FACILITY: Hope Creek Generating Station

SUBJECT: SUMMARY OF REACTOR SYSTEMS BRANCH DRAFT SER OPEN ITEMS MEETING

MEETING TITLE: REACTOR SYSTEMS BRANCH DRAFT SER OPEN ITEMS MEETING  
APPLICANT: PUBLIC SERVICE ELECTRIC & GAS COMPANY  
FACILITY: HOPE CREEK GENERATING STATION  
DATE: WEDNESDAY, JULY 11, 1984

PROPOSED HOPE CREEK LPCI  
PRESSURE INTERLOCK

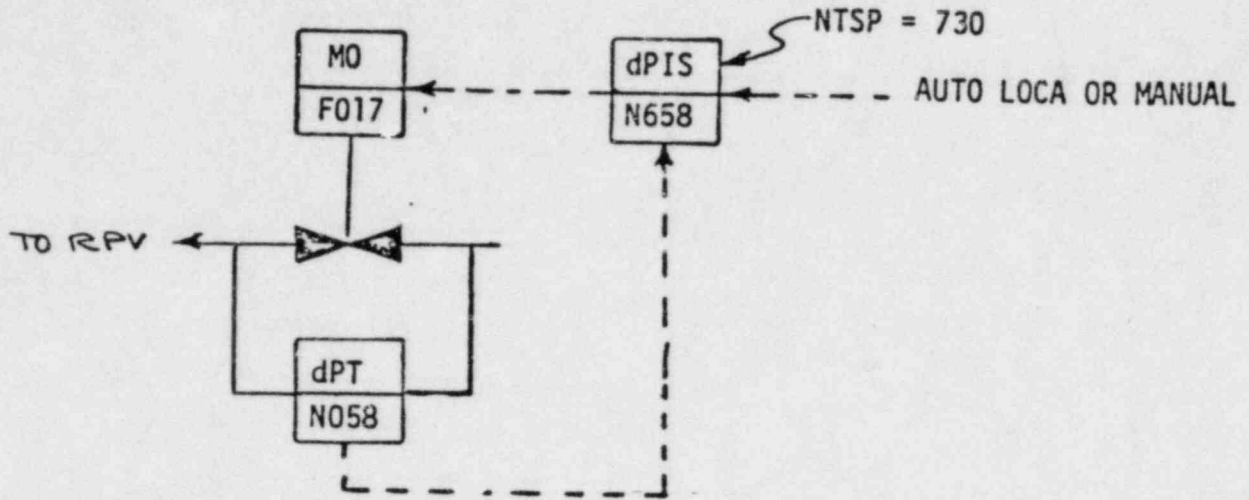
We require the applicant to verify that the LPCS and LPCI injection valves are interlocked to prevent them from opening unless reactor pressure is below the low pressure system design pressure or to conform to one of the acceptable designs given in Section 6.3 of the SRP. (OPEN)

The present design permits the injection valves to open when the differential pressure across the valves is equal to or less than 730 psi. Therefore, the injection valves can open when the reactor pressure is equal to 1080 psig (ie: 730 psi plus the LPCI pump discharge pressure of approximately 350 psi = 1080 psig). The NRC has established the position that this arrangement is unacceptable because a single failure of the inboard testable check valve could result in overpressurization of the LPCI low-pressure piping upstream of the injection valve.

At the meeting the applicant provided a proposed response to this open item (attached). The staff finds this response acceptable. Pending formal submittal of this response by July 31, 1984, the staff considers this item CLOSED.

The proposed design would eliminate this single failure concern by preventing the injection valve from opening when the pressure downstream of the injection valve is greater than the design pressure of the LPCI piping upstream of the injection valve. The pressure indicating switch would have a nominal trip setpoint (NTSP) of 460 psi. Pressure downstream of the injection valve would have to be equal to or less than this NTSP before the automatic or manual open signal would be transmitted to the injection valve. Therefore, the LPCI low-pressure piping that has a design pressure of 500 psi could not be overpressurized by injection valve opening.
